LCIDN34-AA Permit Piney Hill  
Acres

Reference: **Current Elevation of Landfill Excavation  
Piney Hill Acres LCID Landfill - Solid Waste Permit Number 34-AA  
2081 Piney Grove Road  
Kernersville, North Carolina  
Trigon Project No. 042-06-002**

Reference: **Request for Modification to Solid Waste Permit Number 34AA  
 Piney Hill Acres LCID Landfill  
 2081 Piney Grove Road  
 Kernersville, North Carolina  
 Trigon Project No. 015-04-121**

Reference: **Request for Modification to Solid Waste Permit Number 34-90-16  
Piney Hill Acres LCID Landfill  
2081 Piney Grove Road  
Kernersville, North Carolina  
Trigon Project No. 015-04-121**

Drawing No. 011-01-083-6

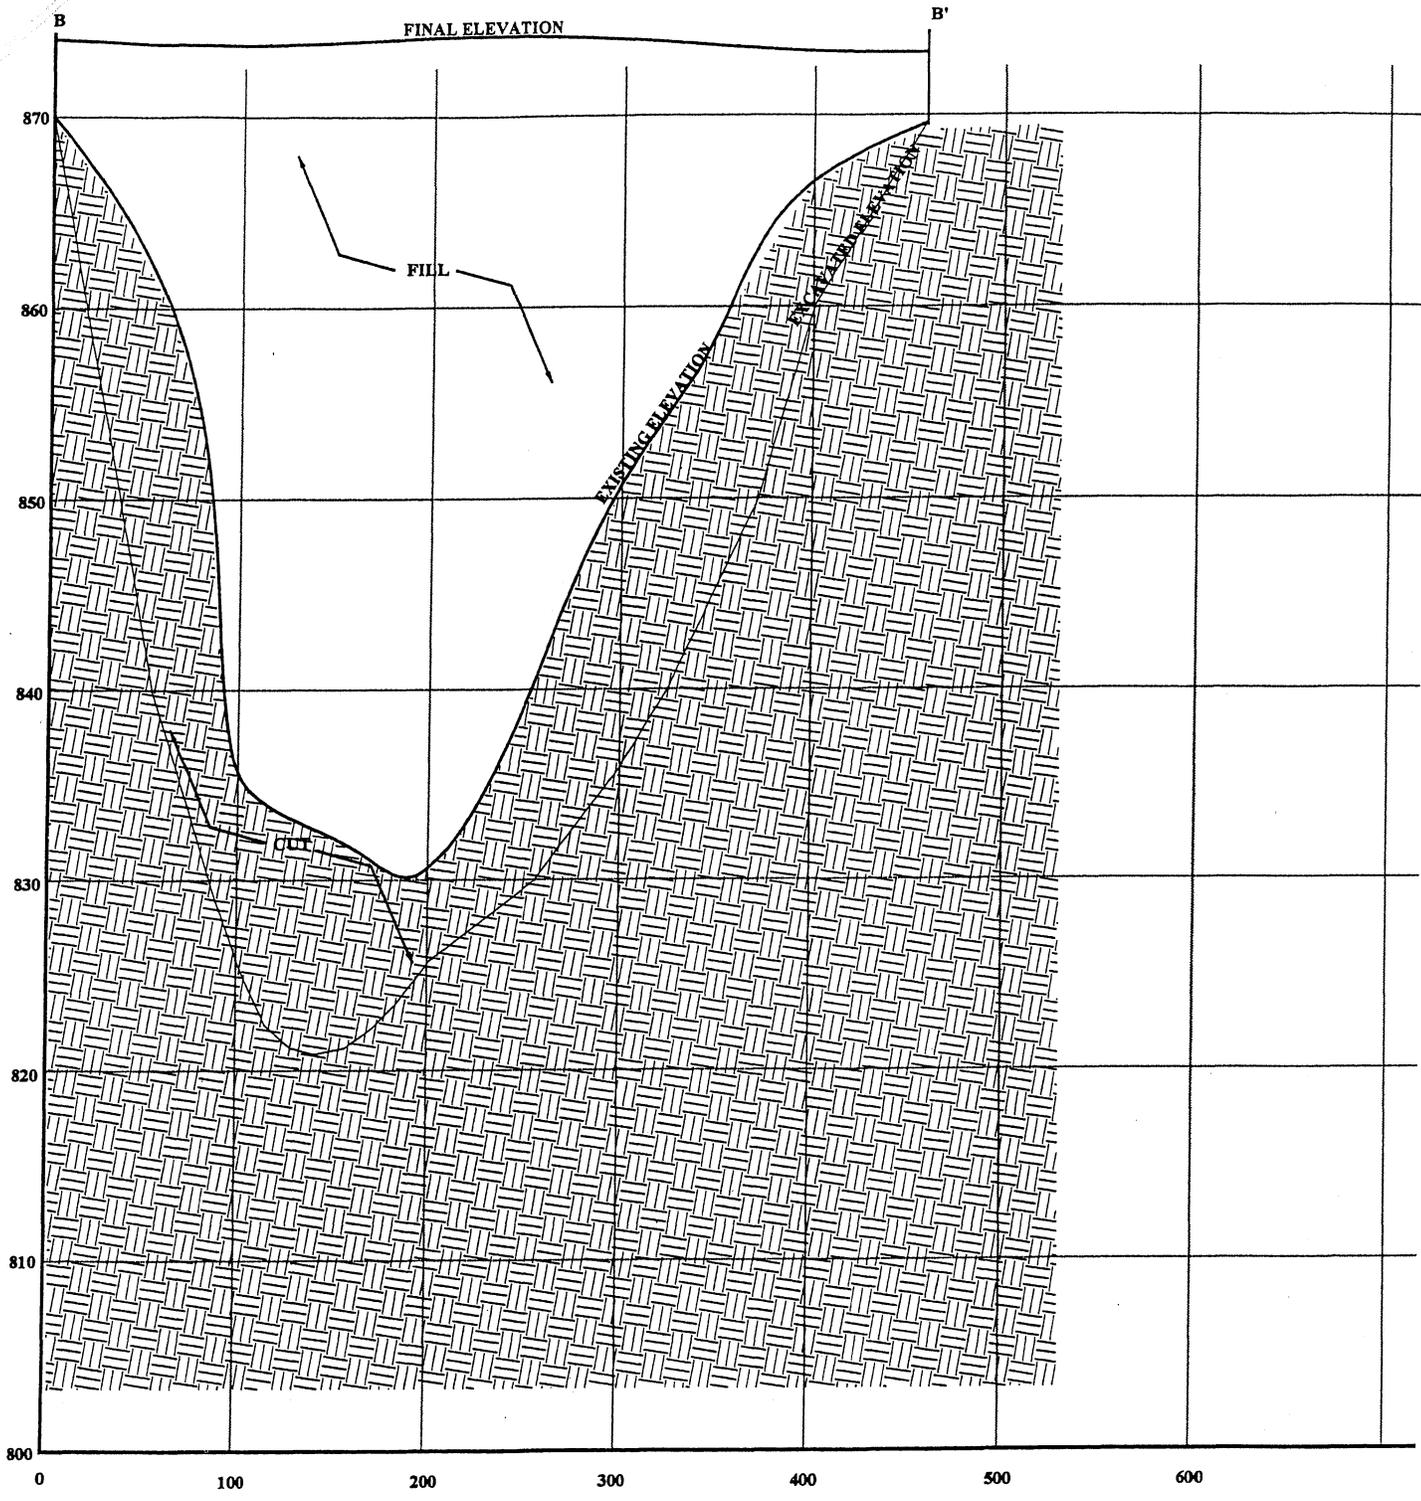
Trigon Engineering Consultants, Inc. (Trigon) is submitting original copies of Drawings 1 through 5 as approved under Solid Waste Permit Number 34-90-16 as amended September 12, 2002, modified Drawings 6 and 7, and a new drawing (Drawing 8). The purpose for the modification is the property owner/LCID landfill operator's desire to excavate portions of the footprint of the landfill prior to placing fill materials. The intent of this letter and submission of the drawings is to request that the existing permit be modified to allow excavation within the footprint of the landfill.

Prior to completing the modifications to the drawings, a test pit was excavated at the location of the former Test Pit 2 to a depth of 20 feet below ground surface. Trigon visually observed the soils excavated from the test pit including the sidewalls and bottom. No evidence of encountering the vadose zone or groundwater table was observed in the soils, and no water was present in the test pit two days after it was excavated. Based on recent hydrological conditions, we believe a maximum depth of excavation of 15 feet below the lowest existing elevations of the landfill will remain 4 feet above the seasonal high water table. Drawings 6 and 7 are our original Cross-Section A-A' and B-B' with the addition of our recommendations for maximum depths of excavation. Drawing 8 shows the locations of the two cross-sections in plan view as

Scale: 1" = 200'  
Drawing No.: 015-04-121-3

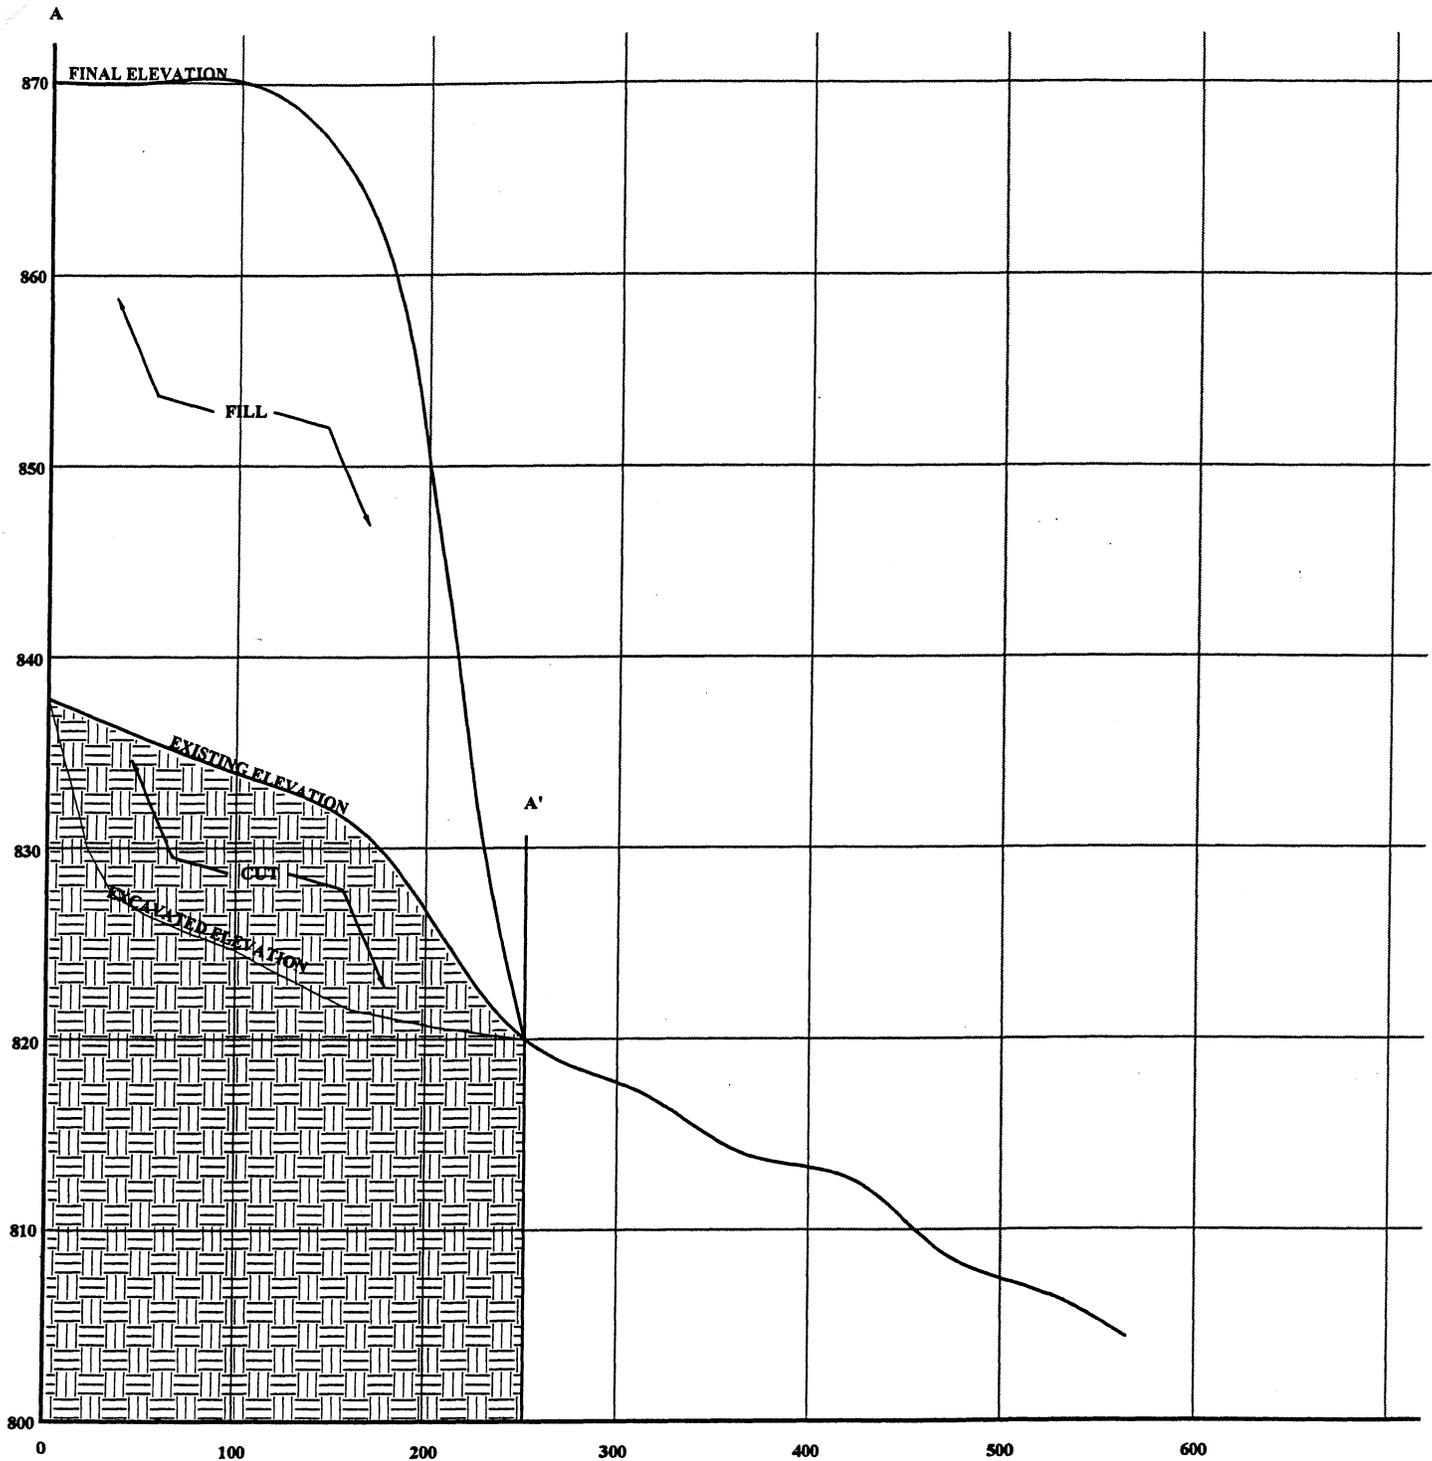
Trigon Engineering Consultants, Inc. (Trigon) is requesting approval to excavate additional materials from the bottom of the referenced LCID landfill as approved under Solid Waste Permit Number 34AA. The purpose for the modification is the property owner/LCID landfill operator's desire to excavate portions of the footprint of the landfill prior to placing fill materials. The intent of this letter is to request that the existing permit be modified to allow additional excavation within the footprint of the landfill.

March 12, 2005 test pit 4 was excavated in the vicinity of the former Test Pit 2 to a depth of 16 feet below ground surface. Trigon visually observed the soils excavated from the test pit including the sidewalls and bottom. No evidence of encountering the vadose zone or groundwater table was observed in the soils, and no water was present in the test pit two days after it was excavated. Based on recent hydrological conditions, we believe a maximum depth of excavation of 12 feet below the lowest existing elevations of the landfill will remain 4 feet above the seasonal high water table. As requested in your March 29, 2005 voice

mail message, a drawing has been attached showing the final elevations of the landfill with the requested modification (Drawing 015-04-121-3).

Drawing No. 011-01-083-6

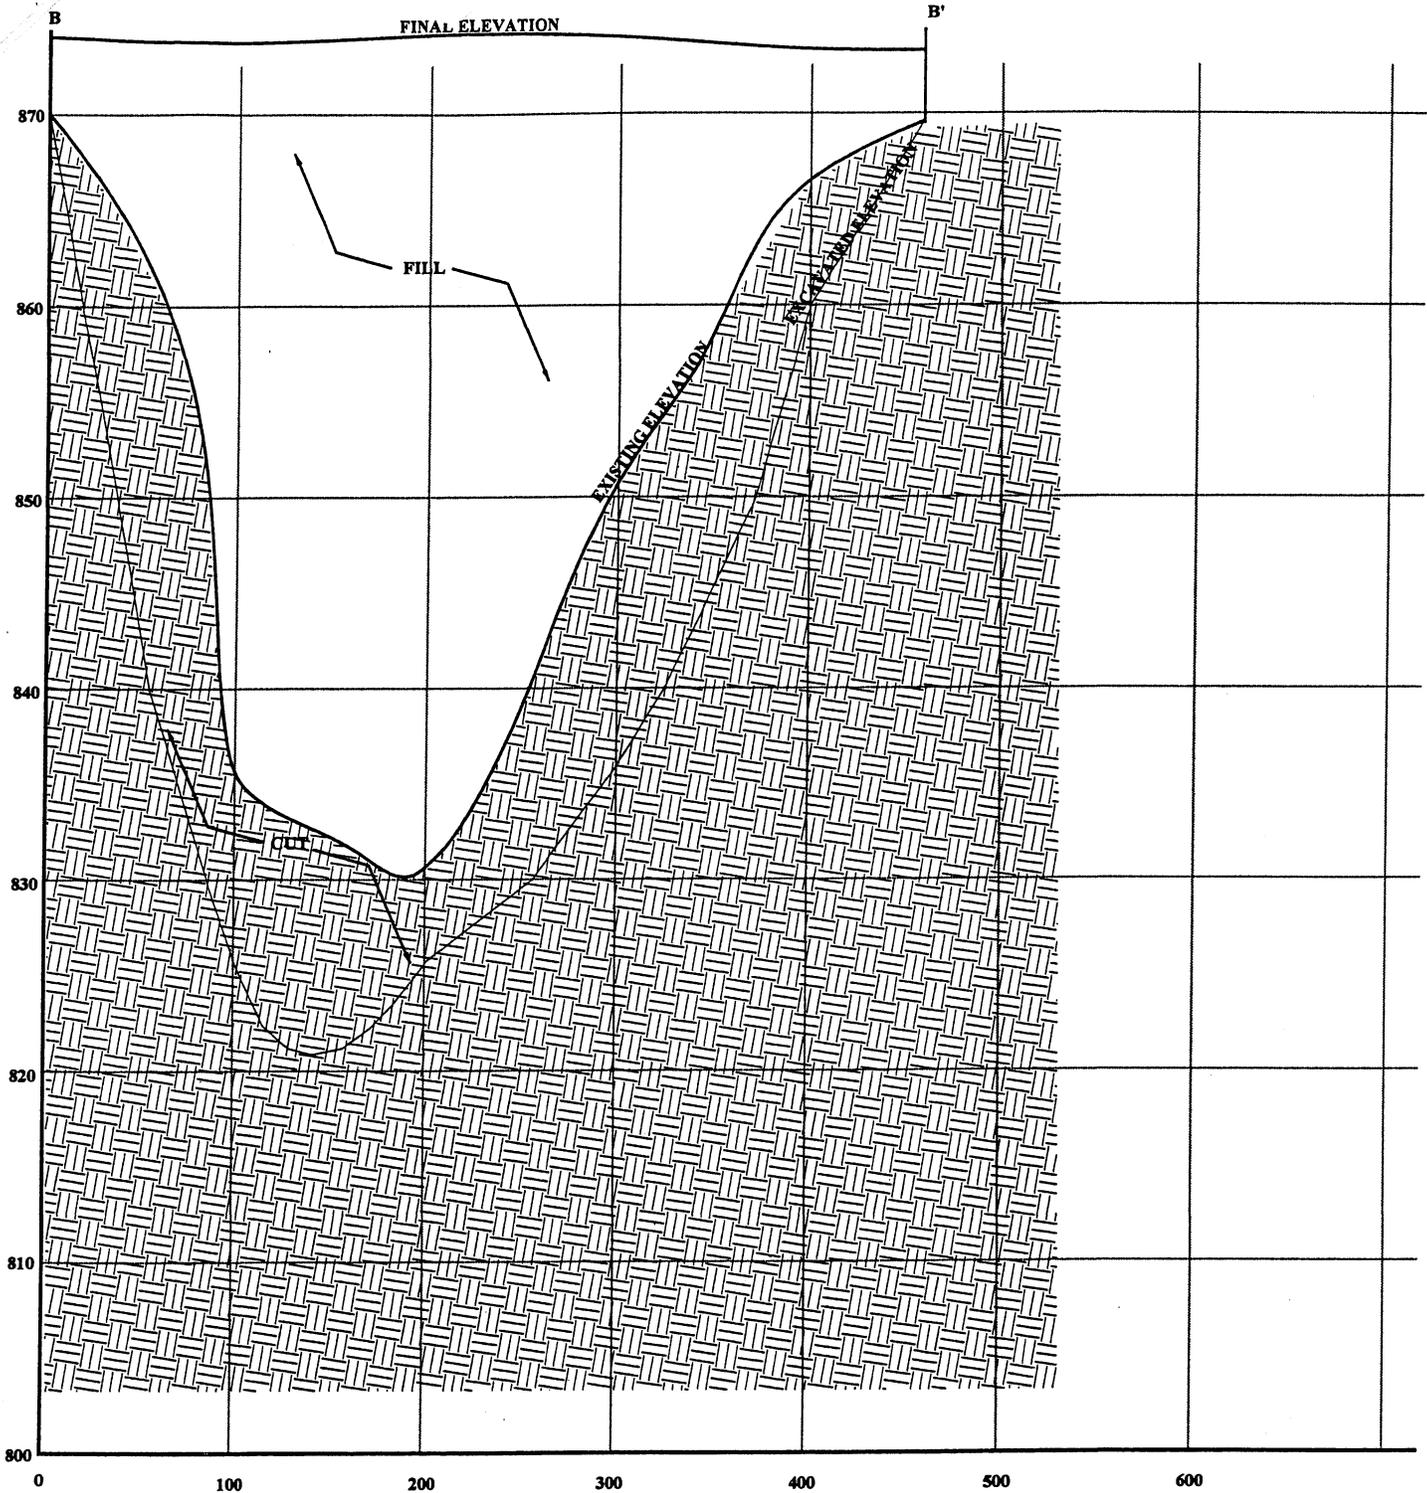
7. Letter from Trigon Consultants dated March 30, 2005, addressed to Tim Jewett, Solid Waste Section, requesting approval to excavate to a maximum depth of 12 feet below the lowest existing elevation along with a copy of Drawing 015-04-121-3 showing the location of the additional cut area, Cross-Section A-A' (Drawing 011-01-083-6) and Cross-Section B-B' ((Drawing 011-01-083-7) demonstrating the bottom cut elevation of 810 feet.
